**US Army Corps
of Engineers®**
St. Paul District

Comments and Responses Appendix F

Fargo Moorhead Metropolitan Area
Flood Risk Management Project

EA Document

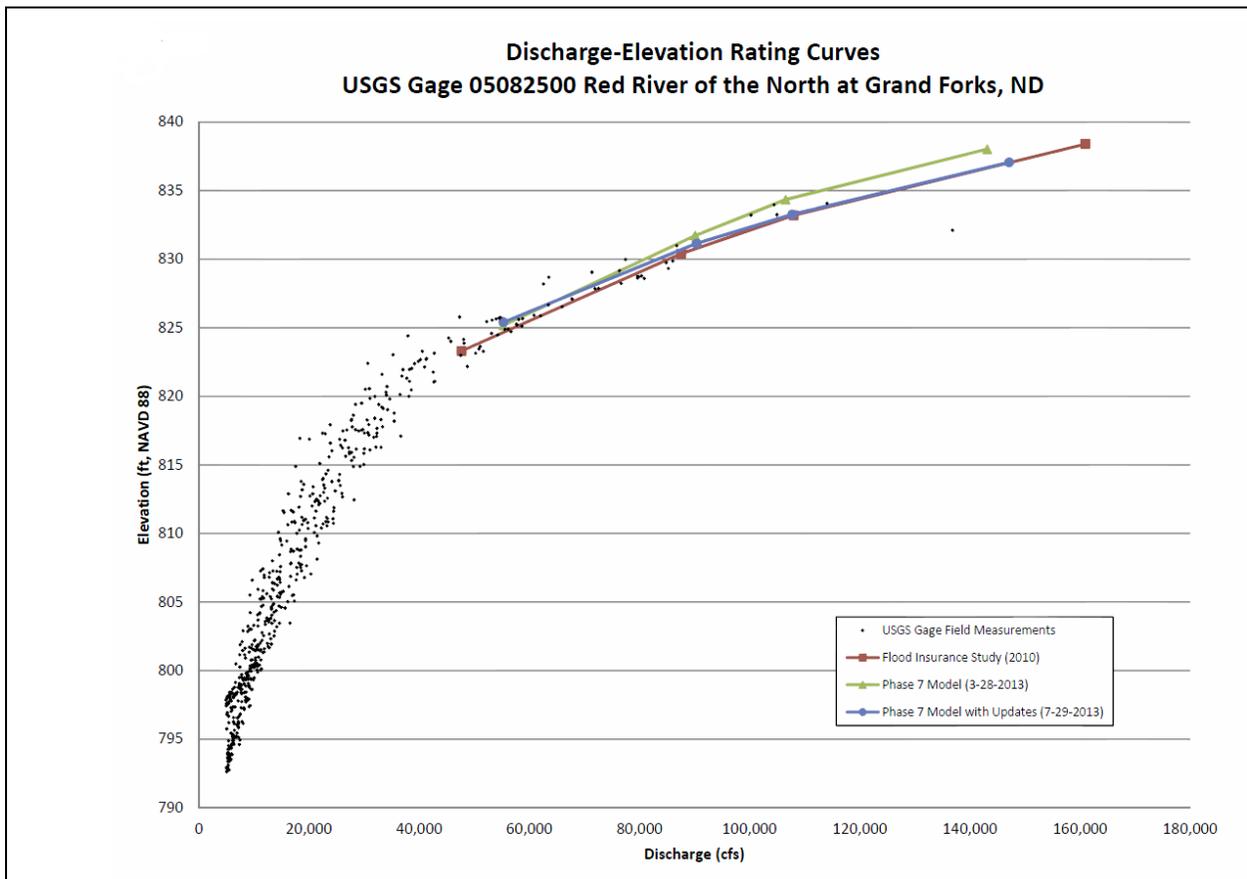
The HEC-RAS model needs to be calibrated to available discharge and high water mark information; the information provided in the EA depicts a surface water elevation change from the existing condition 100 year water surface elevation at Grand Forks. To further elaborate, although the latest study shows little relative significant impact(s) at the Grand Forks locations, these findings are predicated on a different baseline of conditions and models than the baseline on which the current Grand Forks flood protection project was designed and constructed. This difference needs to be clarified within the EA and presented in both current and future analysis.

Response: In response to this comment, the model has been extended to Drayton, ND and was re-calibrated. Now, the model is more closely calibrated to the high water marks from 2009. It also closely matches the specific events as presented in the Grand Forks County Flood Insurance Study (FIS). Figures 7 – 10 of Appendix D of the EA have been updated to reflect the recalibrated model.

For Grand Forks specifically, the tables and figure provided here show the 10-percent chance (10-year) event, 2-percent chance (50-year) event, 1-percent chance (100-year) event, and 0.2-percent chance (500-year) event discharges and elevations from the most recent Grand Forks FIS, the FEIS (feasibility study) and the Phase 7 modeling results used for the draft EA, and the recently updated Phase 7 results.

Of note, the Grand Forks FIS from 2010 presents the 1-percent chance event water surface at the USGS Gage 05082500 Red River of the North at Grand Forks, ND (Grand Forks Gage) to be 833.2 (NAVD88).

The updated Phase 7 model's 1-percent chance event stage is 833.4 (NAVD88). Although the absolute elevations of flood events at the Grand Forks gage were higher in the original Phase 7 modeling used for the draft EA than in the Grand Forks FIS and the updated Phase 7 model results, the relative project impacts are nearly the same (far right column of tables).
